PCN: V18-002-F48070-MA

Product Change Notice

Issue Date: 25 July 2018

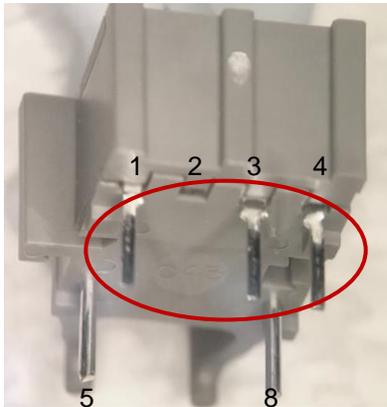
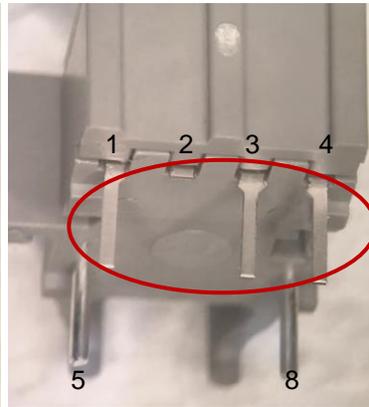
1. Qualify new lead-frame with increased distance between pin2 and pin3.
2. Qualify NiPdAu plating.

Active pins (pin1 to pin4 in red circle): Affected by changing to new NiPdAu lead-frame finish.

Housing staple pins (pin5 and pin8): No Change.

1. Increase the distance between pin2 and pin3 to reduce the possibility of electric shorting.
2. Eliminate additional solder dip process by implementing NiPdAu Pre-plated lead-frame to improve product reliability, product cycle time and to simplify lead-frame supply chain. The NiPdAu pre-plated lead-frame has been qualified and used in other Broadcom industrial products since year 2015. Lead frame base material remains unchanged.
